***MAJOR PROJECT ASSESSMENT:
Coffs Harbour Water Treatment Plant***

Director-General's
Environmental Assessment Report
Section 75I of the
Environmental Planning and Assessment Act 1979

September 2007

Figure 4: Operational Noise Assessment

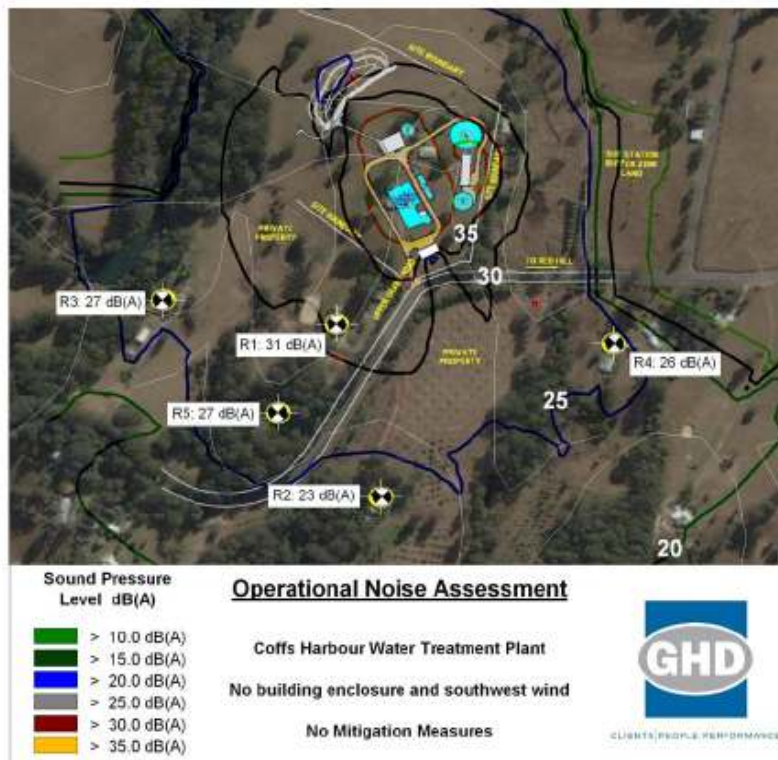
The operational noise assessment was conducted in accordance with DECC's *Industrial Noise Policy*. The noise modelling was based on 24 hour operations and considered topography, weather conditions, reflection, ground absorption, site sources and the location of the receiver areas to predict received noise levels from the proposed WTP. A number of modelling scenarios with differing meteorological and operational conditions were conducted. This included a worst-case scenario where all noise sources are to operate continuously at any one time and there is no structure over the rapid mix and flocculator tanks with wind towards the southwest in the direction of the closest residential receiver. The results of this scenario, illustrated in **Figure 4**, indicated that the sound levels at the nearest receivers would be in the range of 23–31 dB(A). Based on this modelling, the Environmental Assessment concluded that the operational noise is unlikely to exceed the project specific noise goal of 35 dB(A).

The Proponent's Statement of Commitments indicated that all noise sources will be located within buildings and acoustically treated rooms to provide the noise attenuation modelled in the noise impact assessment. The conservative nature of the noise modelling and the application of this mitigation measure would ensure that operational noise would not be an issue for the adjacent residences. The Department is satisfied that operational noise would be low and would meet the project's adopted operational noise goal.

To ensure that operation noise from the new WTP does not exceed 35 dB(A) at the nearest and most affected property boundary, the Department recommends a condition that requires the plant to not exceed this noise goal for the life of the project. Noise monitoring is required to be undertaken in accordance with Section 11.1 - Monitoring Environmental Noise of the *NSW Industrial Noise Policy*.

Figure 5: Locality of Adjacent Residences

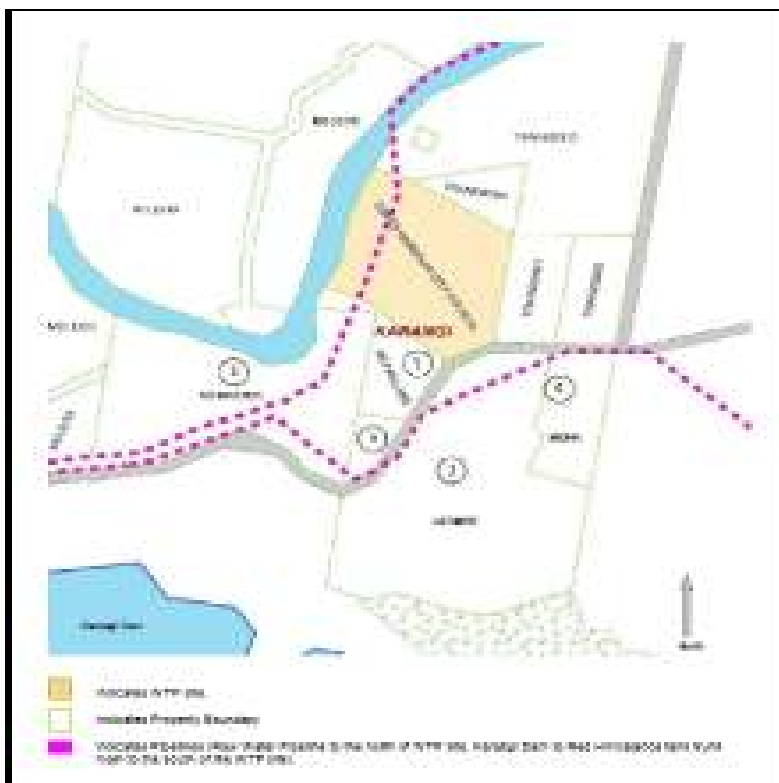
The visual impact assessment undertaken in the Environmental Assessment identified the potentially affected properties (as shown in **Figure 5**), considered the existing views to the project site, the visual character of the surrounding landscape, sensitivity of the landscape to alteration by the proposed facility, visual character and extent of the facility, and 'viewer-sensitivity' to alteration of the existing visual environment by the project.

Of the surrounding properties, only two (Nos 146 and 186 Upper Orara Road) were identified as having partial views to the project site and would experience medium visual impact. **Figures 6 and 7** provide a visual impression of the proposed WTP from these properties. The Department notes that for No 146, the illustrated views of the plant are from within the property but not from the house itself where existing trees provide a screen of the plant site.

The Department considers that the visual illustration of the project in the Environmental Assessment provided only a basic impression of the design and appearance of the proposed facility. It also notes that none of the submissions commented on the architectural design and appearance of the plant. Based on the photomontages, there could be some impacts and therefore the Department requires further work to reduce such impacts. Conditions are recommended requiring the Proponent to prepare and submit an Urban Design and Landscaping Plan for the Director-General's approval before construction commences. The Plan is to be prepared in consultation with affected landowners and must contain details of the built elements (including proposed treatments, finishes, materials and colour of exposed surfaces) and landscape elements, including the timing and progressive implementation of the landscaping works.
